TOWN OF LYONS, COLORADO
RESOLUTION 2020-91

**A RESOLUTION OF THE TOWN OF LYONS COLORADO TO APPROVE THE SEVENTH
AMENDMENT TO THE CONSTRUCTION AGREEMENT WITH WALSH CONSTRUCTION INC.
FOR BOHN PARK PHASE II - PROJECT: PW20E-2**

Walsh Construction, Inc.
Change Order Proposals

PROJECT: Town of Lyons - Bohn Park (Phase 2)

INTAKE STRUCTURE 2'-11" X 2'-11" X 6'-0"					
SUBMITTAL DRAWING					
BUSIMARK WALSH CONSTRUCTION INC					
DATE 06/03/19	SALES MH	DRAWN MH	ENGINEER —	CHECKED	SALES ORDER
DRAWING NUMBER 110-C0001922019-1			REVISION	SHEET 1 OF 2	
REV DATE

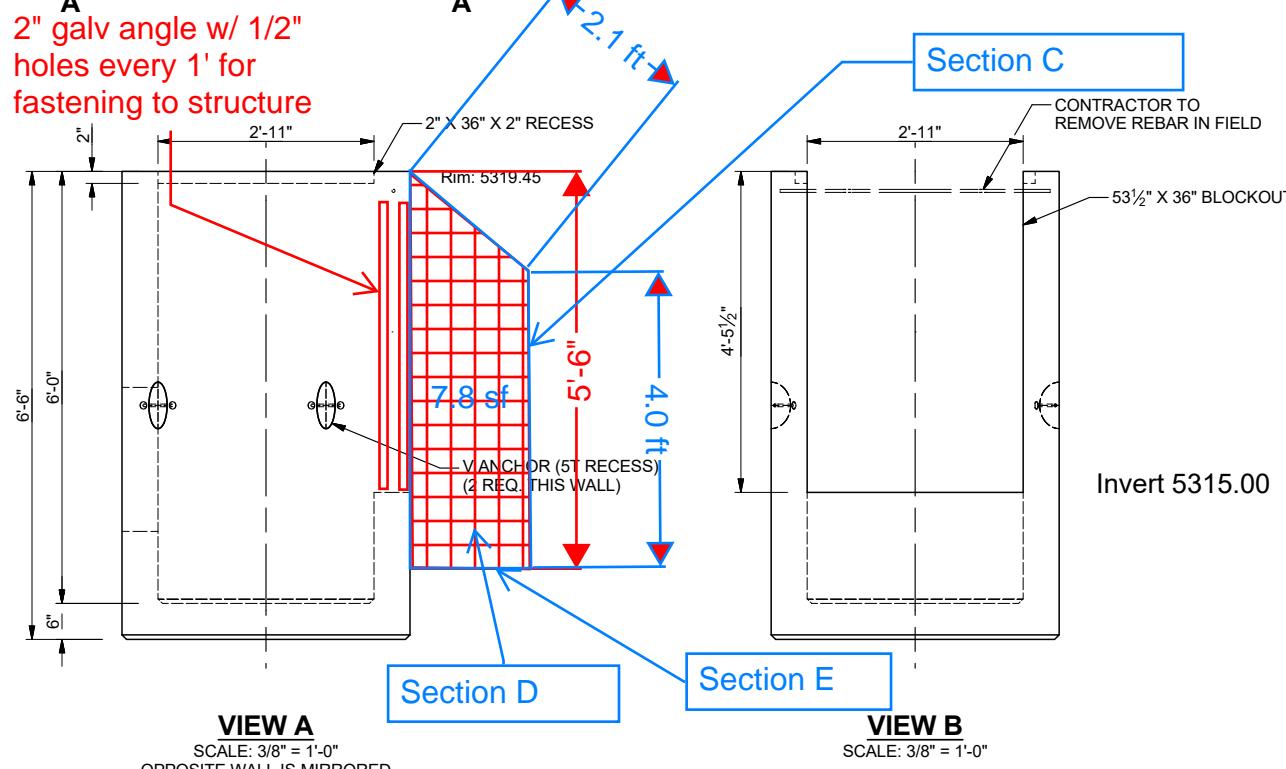
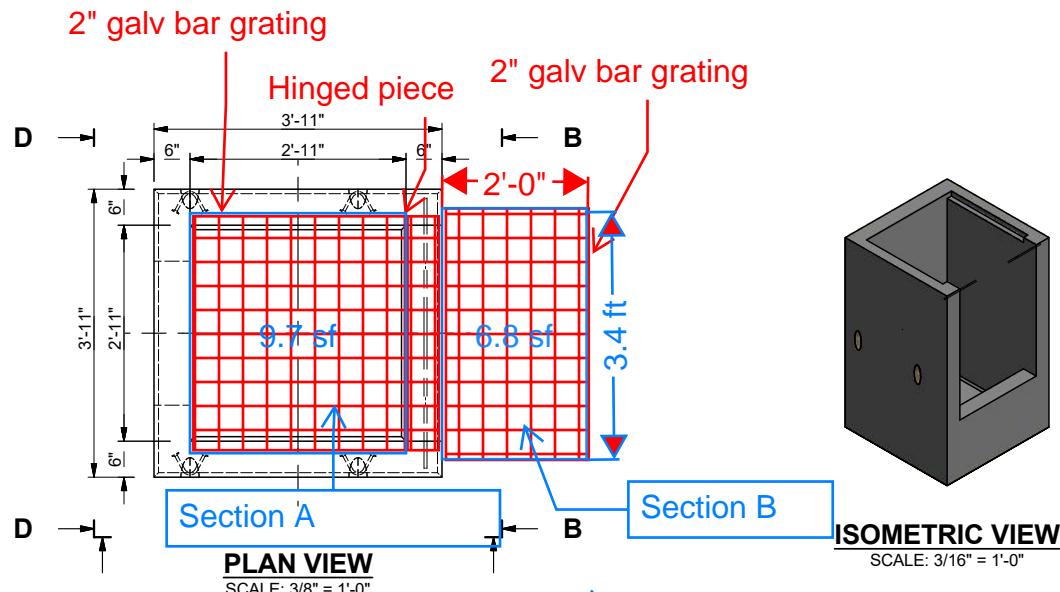
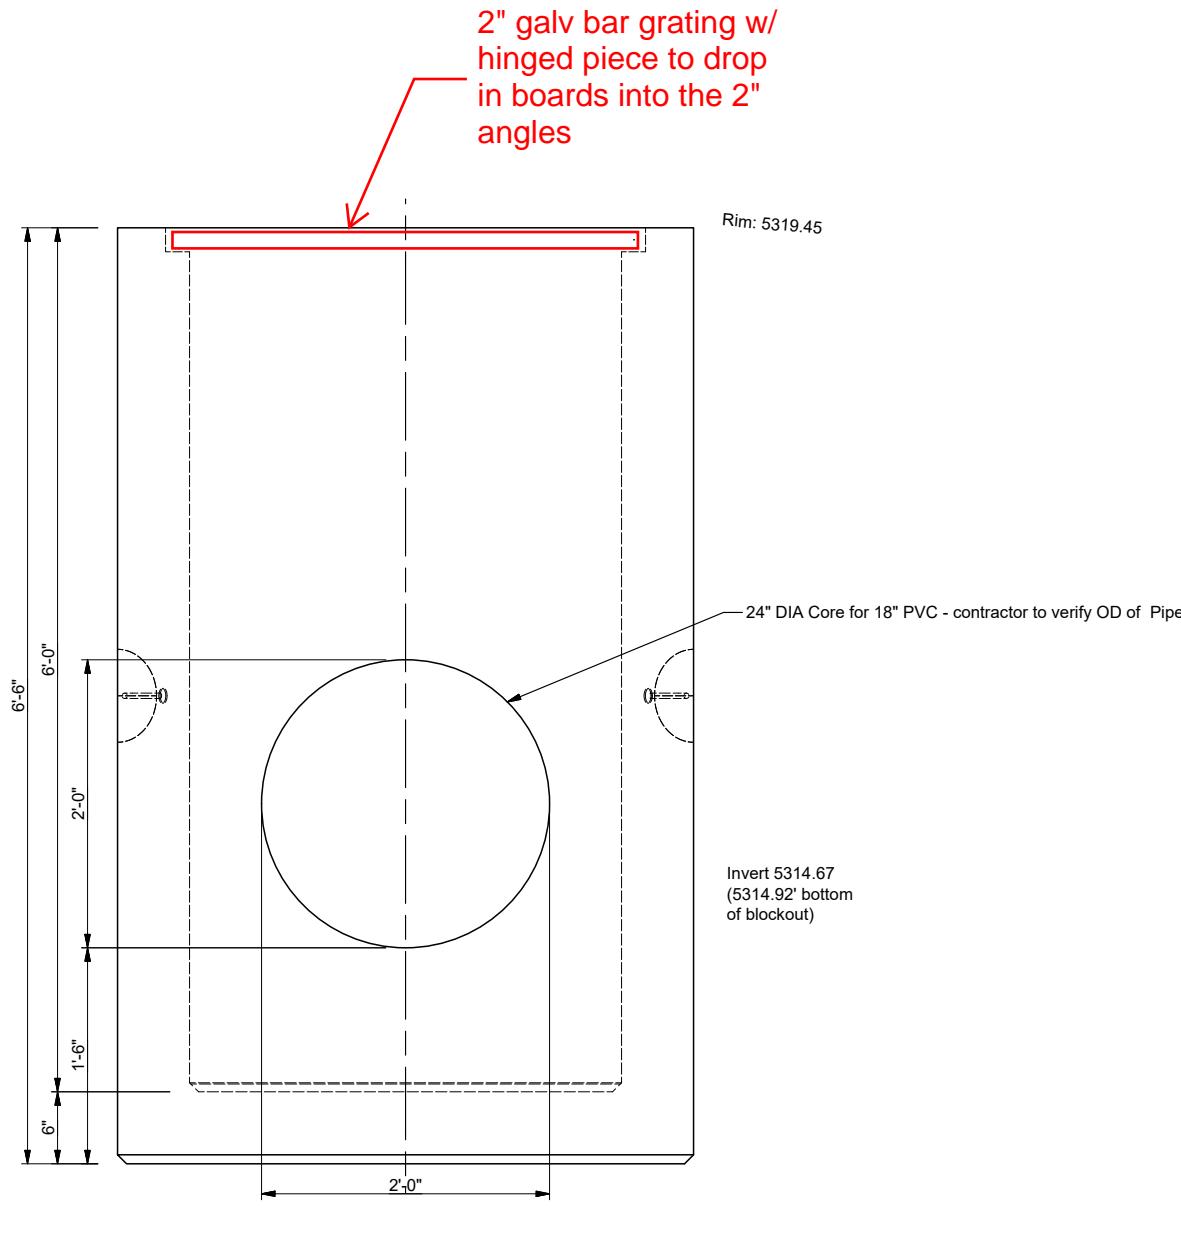
At the direction of the Town, the original plan design for the Pump Station Intake Structure was modified to more closely match the design at the nearby LMJ Diversion Structure. The modification included adding 2" galvanized grating on the top and front face of the structure and angled hinged trash/debris rack. These modifications were necessary to help control the amount of trash and debris entering the structure and to assist with long term maintenance costs. Since this was a specialized and custom design, the cost for materials and labor was found to be fair and reasonable when compared with average material cost data found on websites with similar dimensional and material properties. Labor rates were compared with 2020 Davis Bacon standard wage rates for Boulder County, Colorado and industry standard rates for specialized drafting. As a result of this revision, the Town will receive a material credit for cost of the 2'x2' grate that was included in the original plan design but was not installed due to the revised modifications. This amount will be paid as a Contract Amendment. See attached documents and related plan sheets for breakdown of costs.

Please note: this structure is shown as 3'x3' on the plans, however our form is 2'-11" x 2'-11". This form will allow for a monolithic structure.

Fabricate, galvanize, and install the steel bar grate structure for the inlet structure. This includes the 2" bar grate and the vertical angles to hold the boards. The design will be similar to the pictured structure that is attached.
